## Immingham Green Energy Terminal

10.7 Proposed Further Changes Notification Report

> May 2024 Version 1.0 Planning Inspectorate Scheme Ref: TR030008 Document Reference: TR030008/EXAM/10.7

Appendix 1: Proposed Changes Location Plan – Proposed Changes 5 - 9

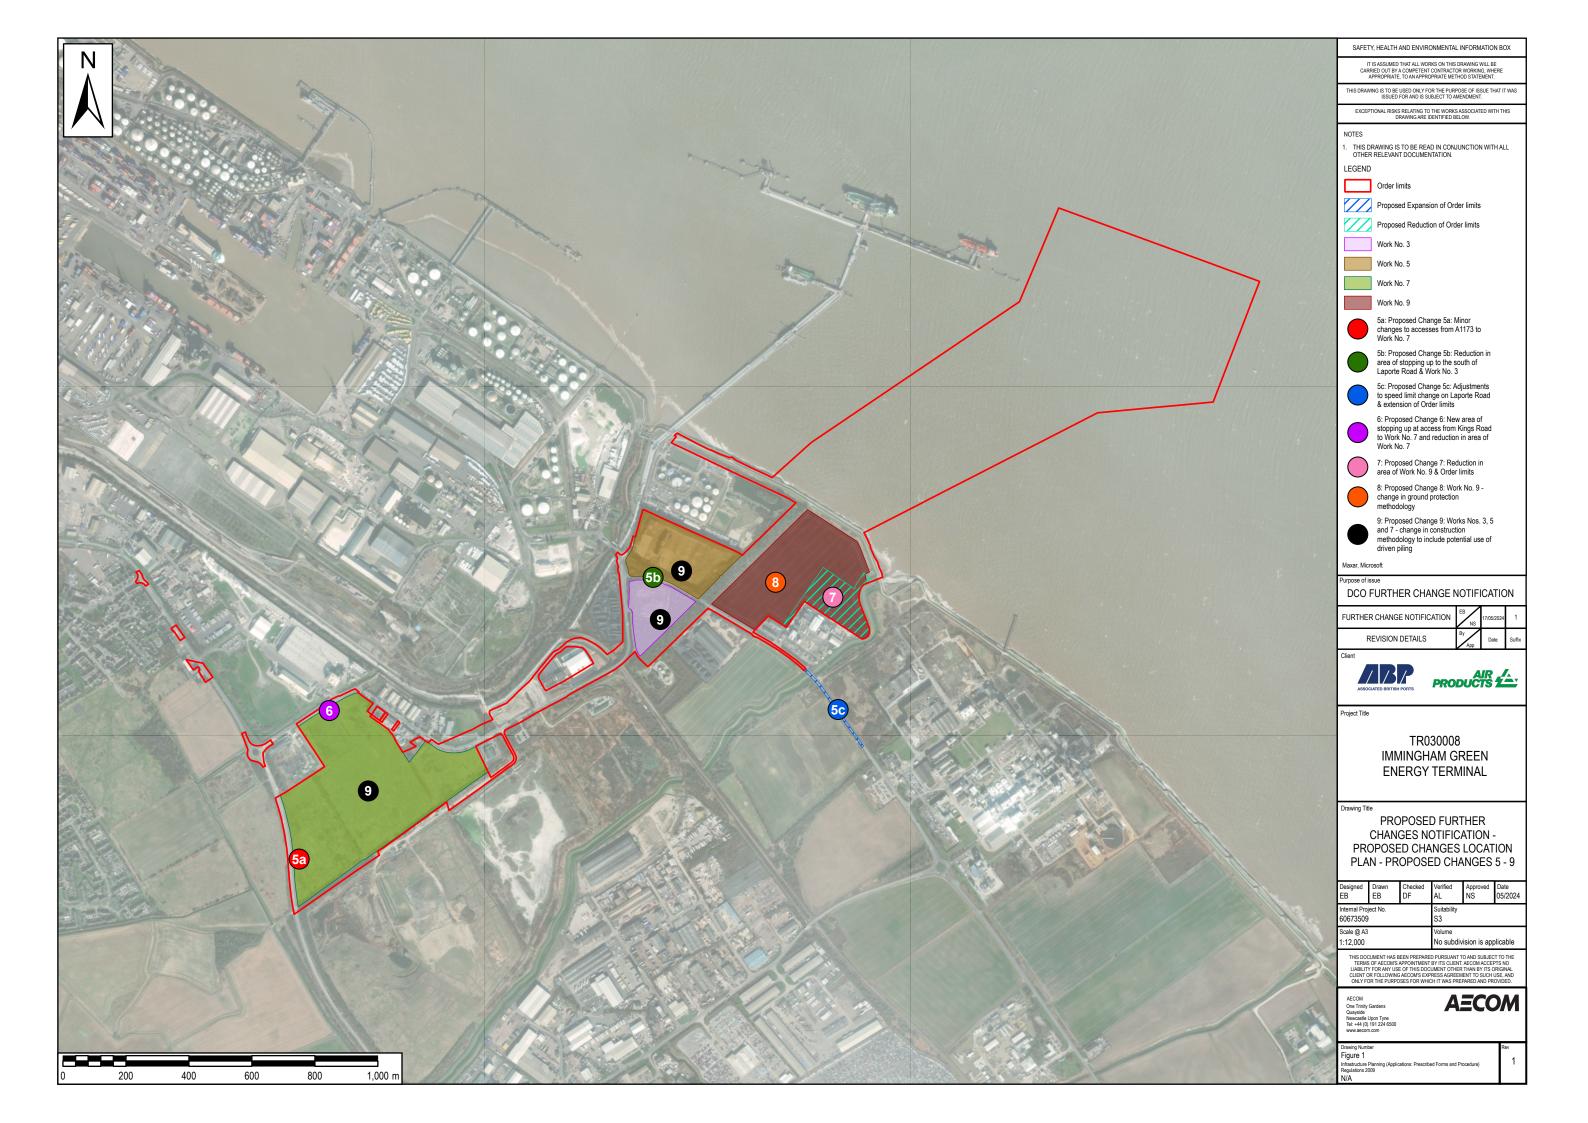
- b. A change to terrestrial piling methodologies in Work Nos. 3, 5 and 7 to include the potential use of driven piling (Proposed Change 9).
- 2.1.3 The location of Proposed Changes 5 9 are illustrated within **Appendix 1**.

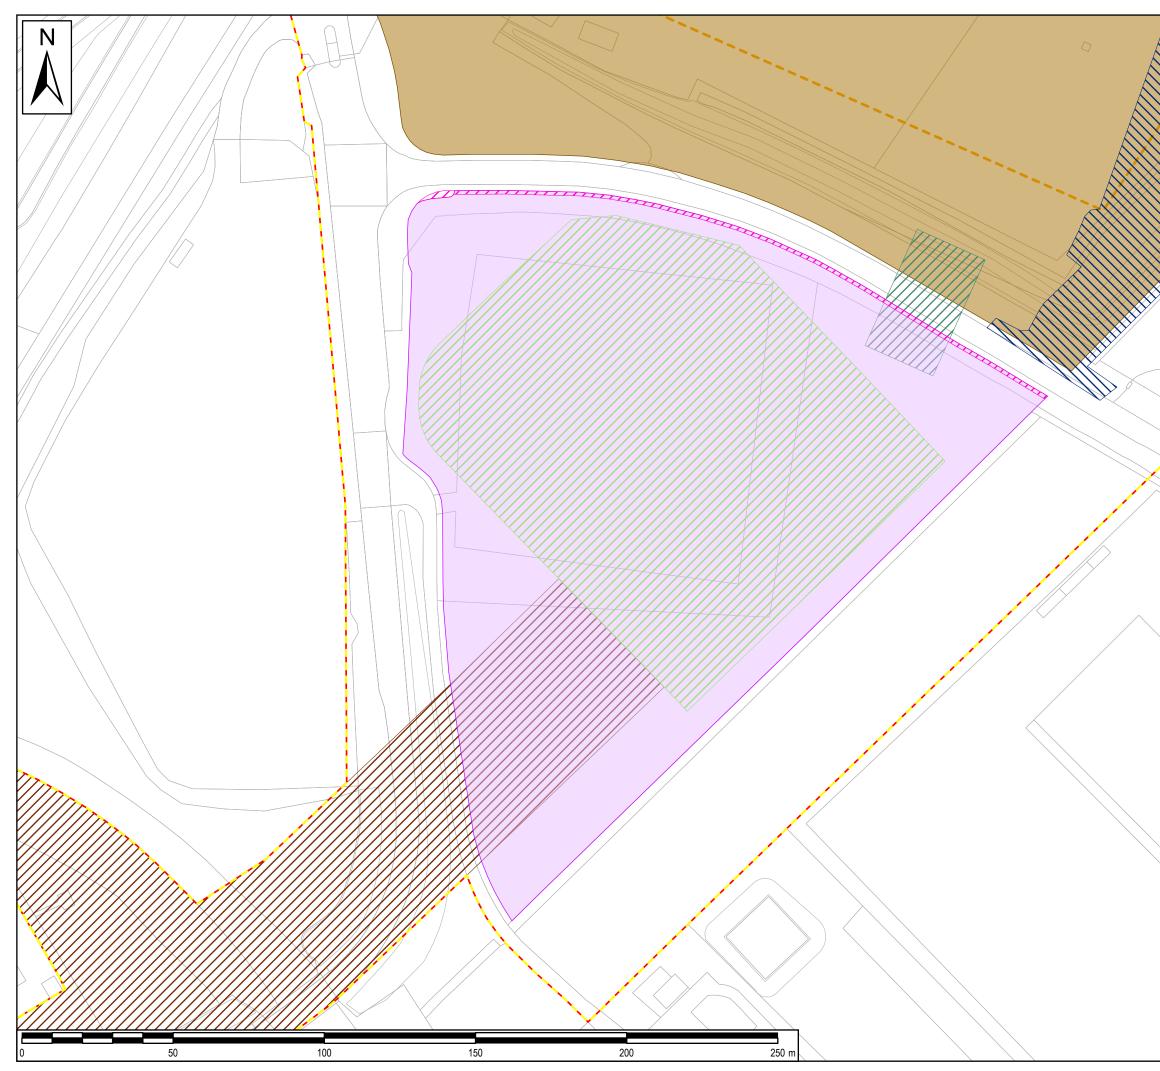
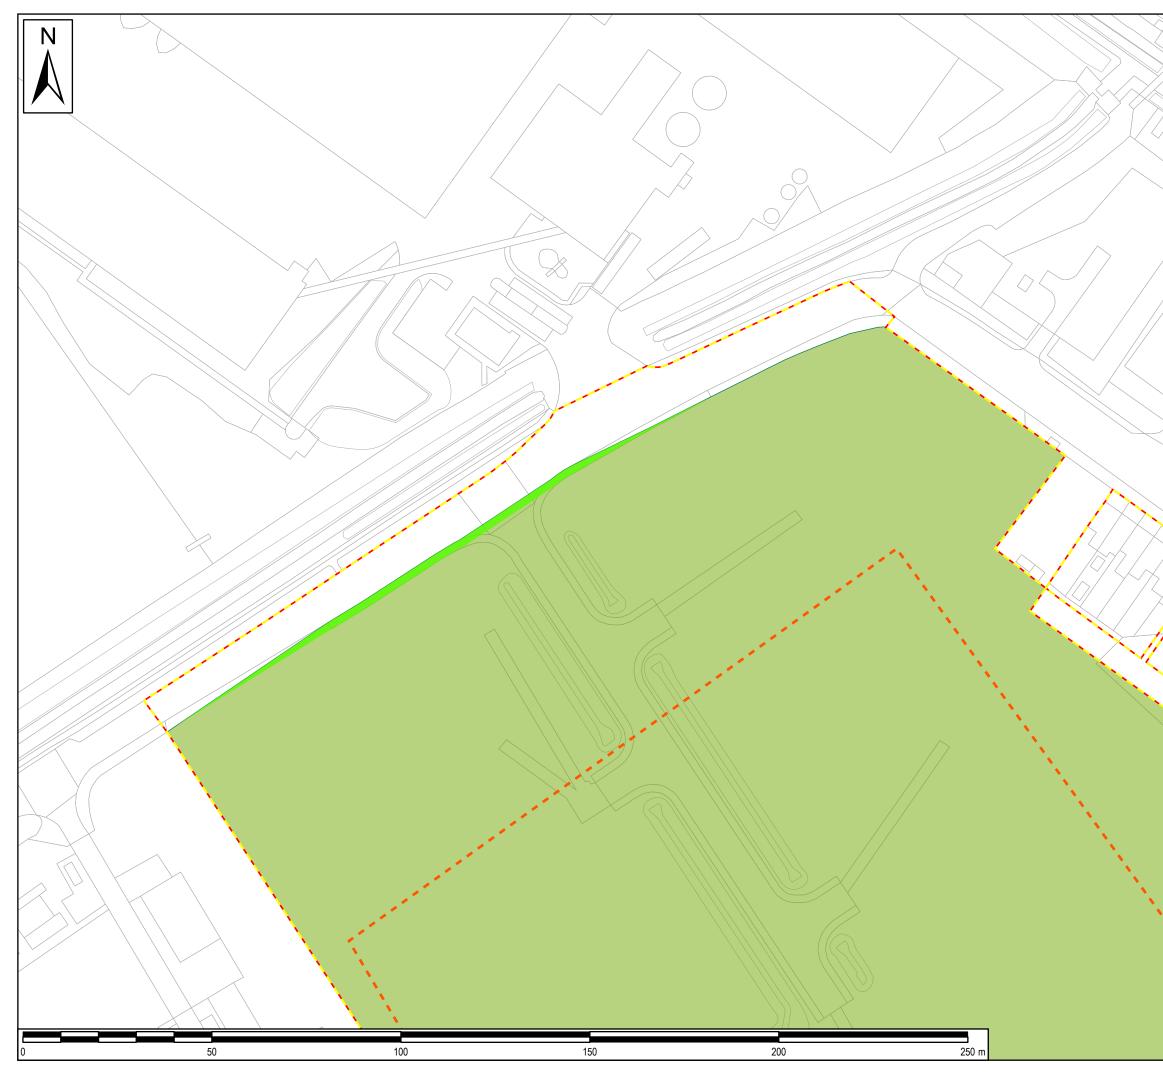
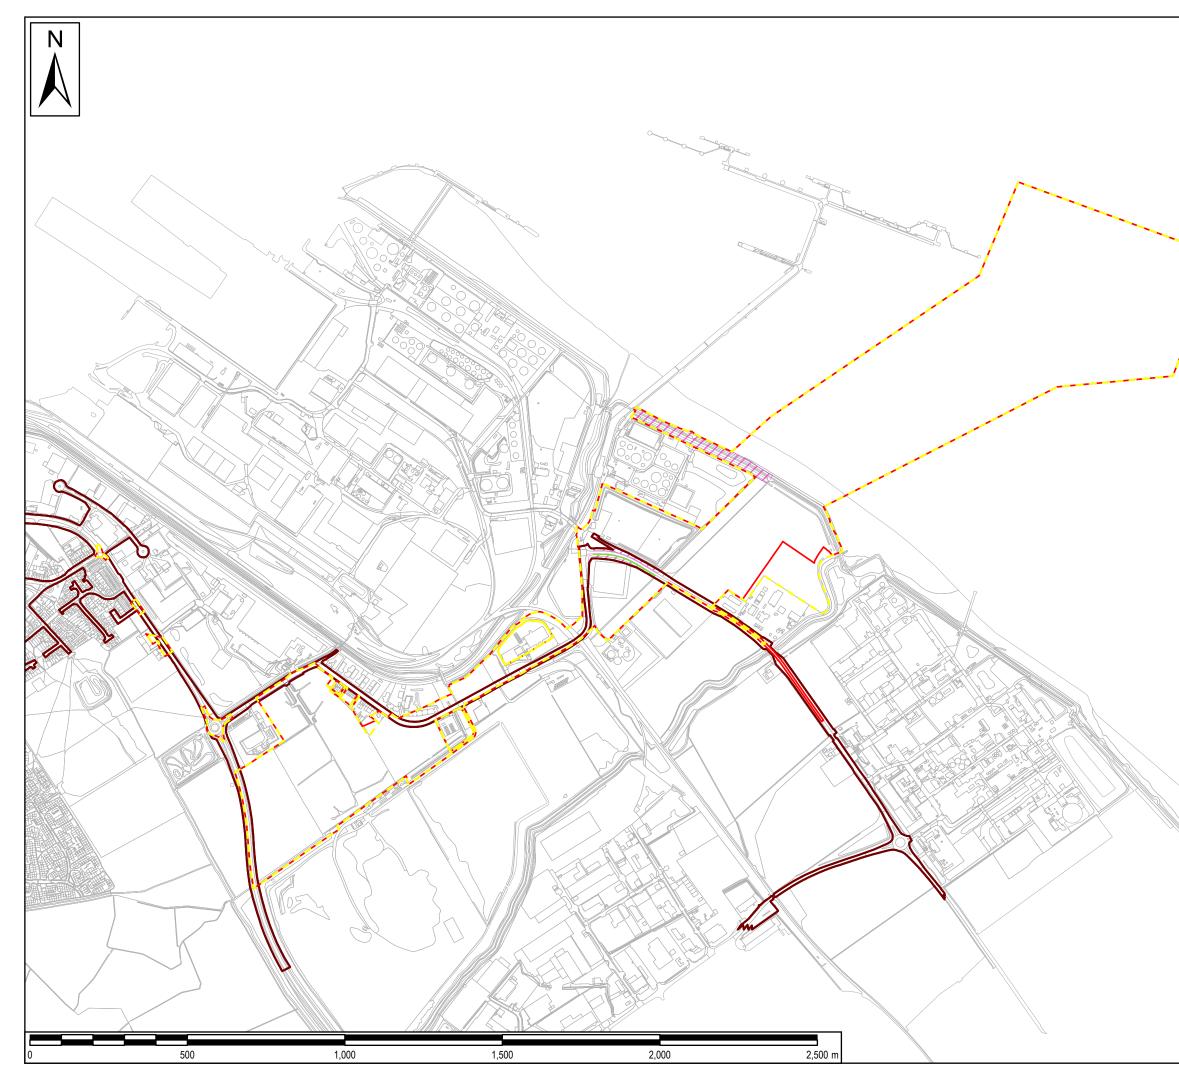
- 2.7.3 **Appendix 1** illustrates the location of the proposed change and **Appendix 2** illustrates the reduction in the Order limits as a result of the reduction in the area of Work No. 9.

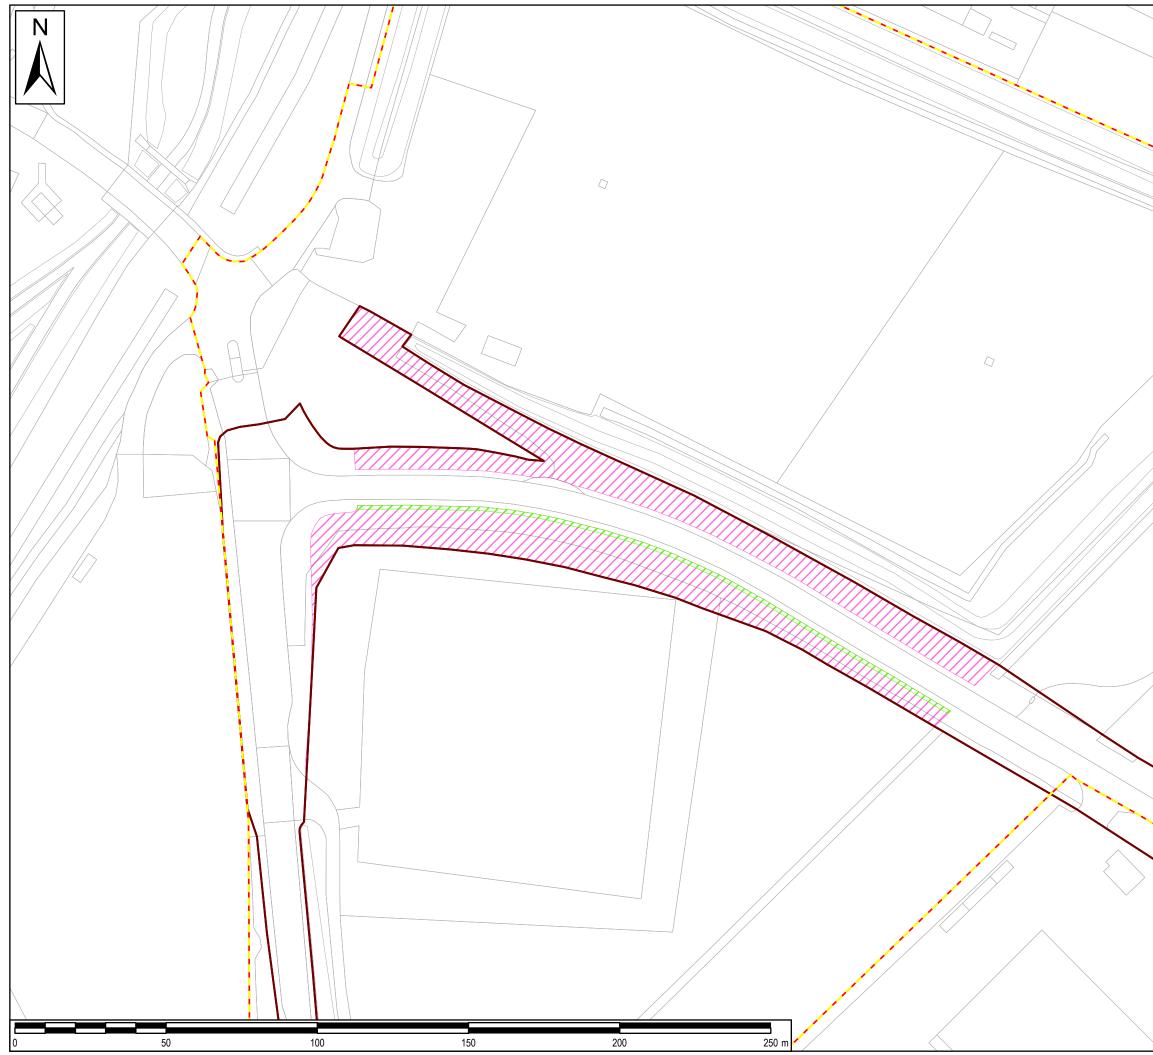
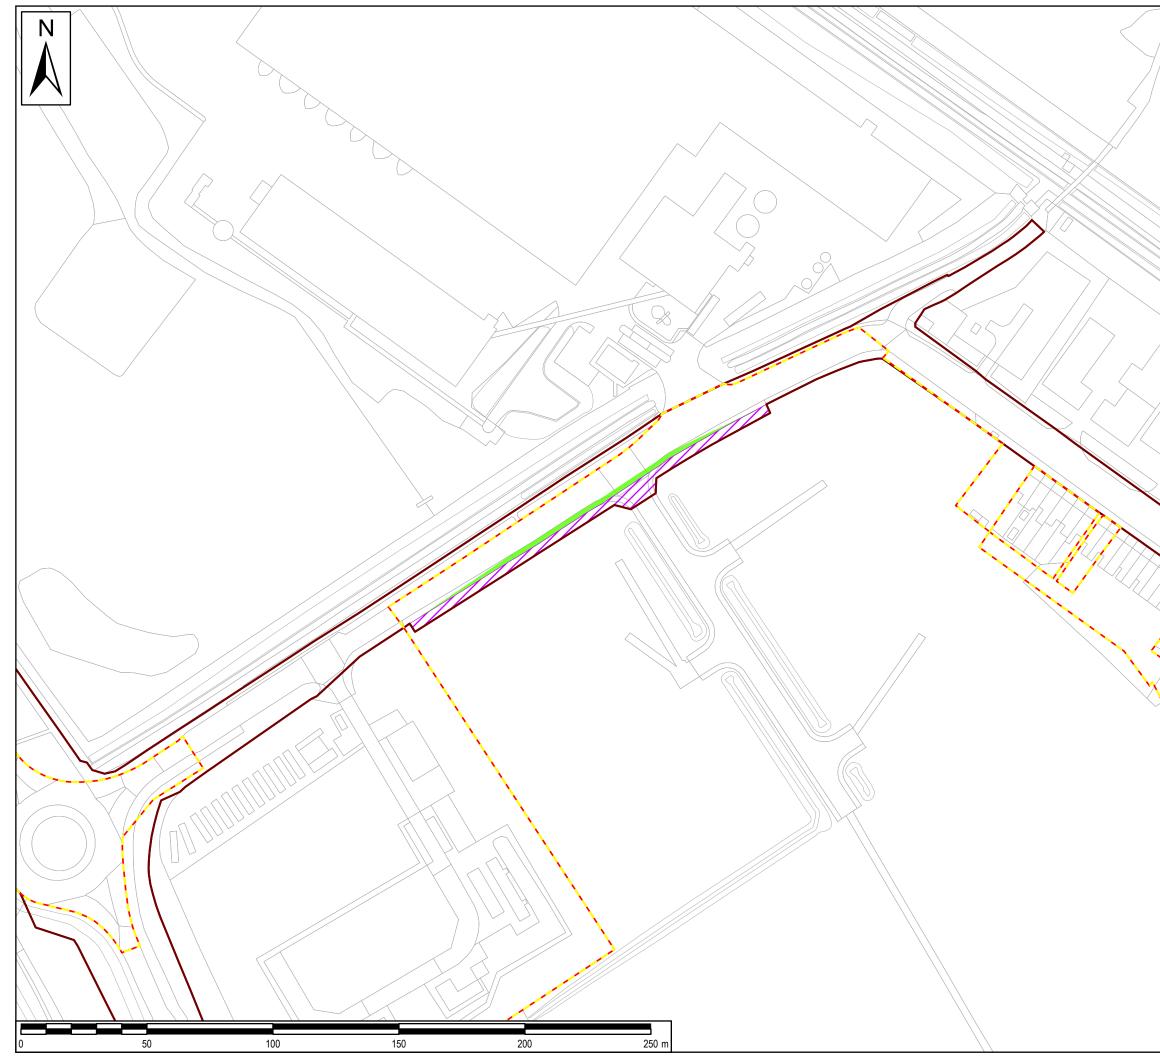
- 2.4.2 **Appendix 1** identifies the location of this proposed change and **Appendix 3** illustrates the details of the proposed change.
- 2.4.3 The need for this change results from engagement with NELC Highways on the detailed design of the retained verges and visibility splays. As a result, there would be a minor (beneficial) reduction of the extent of Work No. 3 of

- 2.6.3 Proposed Change 6 is therefore required to stop up an area of public highway that sits within Work No. 7 in the vicinity of Access AA, with the agreement of NELC Highways. As a result, there would be a minor (beneficial) reduction in Work No. 7. Appendix 1 illustrates the location of the proposed change and Appendix 3 illustrates the proposed area of stopping up.

Appendix 4: Traffic Regulation Measures Plan Changes for Proposed Changes 5 – 9

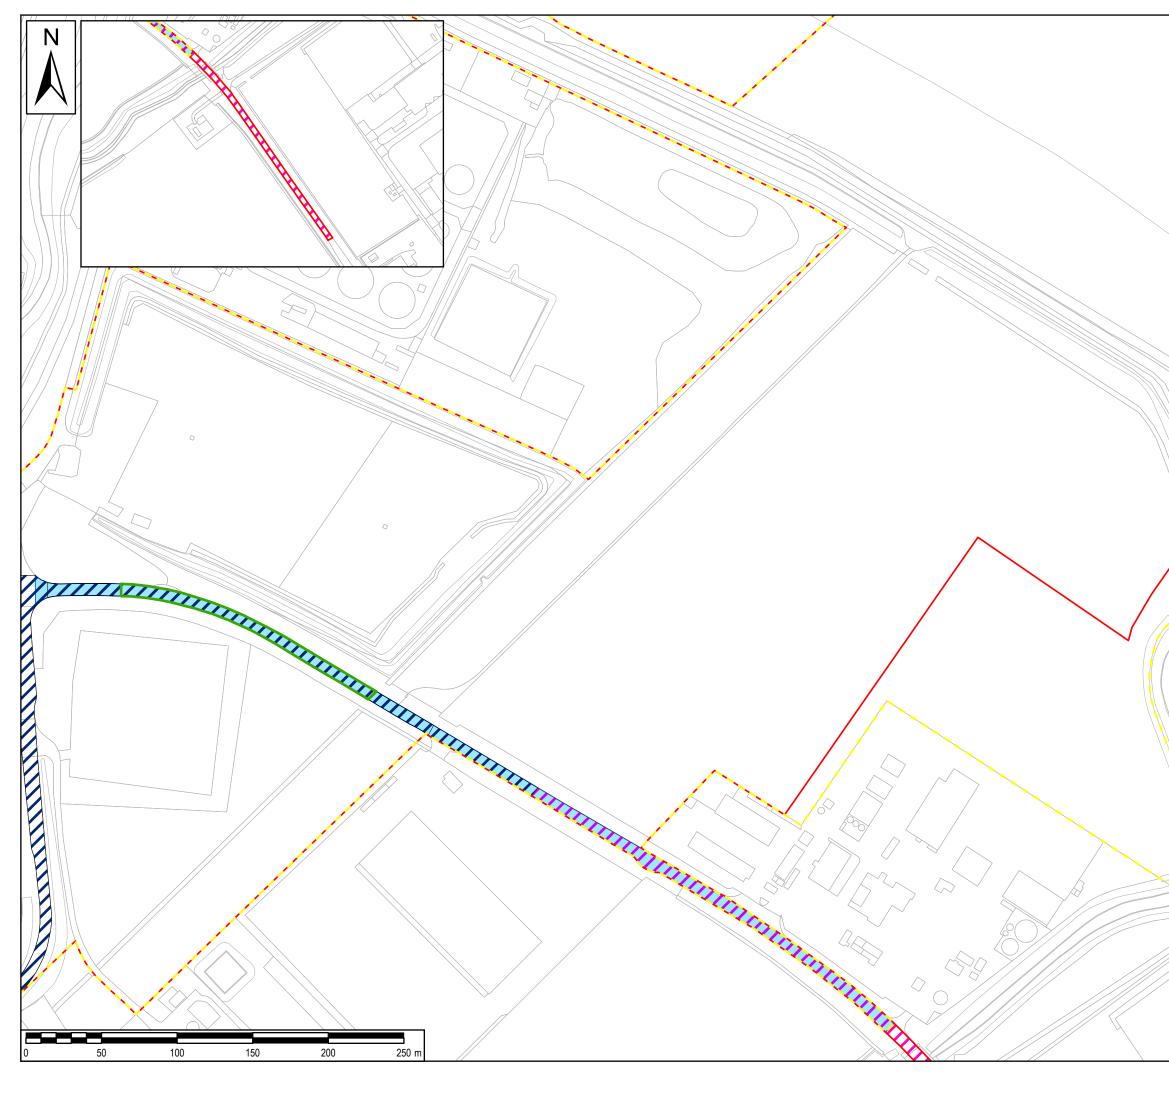
- 2.5.3 It is therefore proposed that the 30mph limit will apply to Laporte Road between the junction with Queens Road and the eastern extent of Access P (Access P is shown on the Street Works and Accesses Plan [REP3-016]). A limit of 40mph is proposed from the eastern extent of Access P for approximately 600m to the point where the existing limit on Laporte Road reduces to 40mph. This will require a short extension (approximately 305m) of the Order limits along the public highway of Laporte Road to encompass the new 40mph section. Appendix 1 illustrates the location of the proposed extension to the Order limits to reflect Proposed Adjustments and the proposed extension to the Order limits to reflect Proposed Change 5(c) and Appendix 4 illustrates the locations of the proposed changes to speed limits.

Figure 1: Proposed Piling Rig Programme and Locations

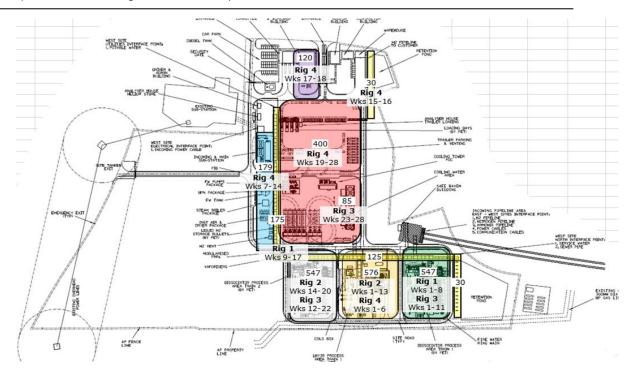
- For Work No. 7 the location of the piling rigs is based on **Figure 1** below, with the worst-case scenario for each NSR based on weeks during which the piling rigs are the closest to the NSR, as follows:

NSR 3 and 4 Weeks 12-14 (Rig 1 in operation in the pale yellow linear areas, Rigs 2 and 3 in operation in the white/pale grey area and Rig 4 in operation in the blue area)
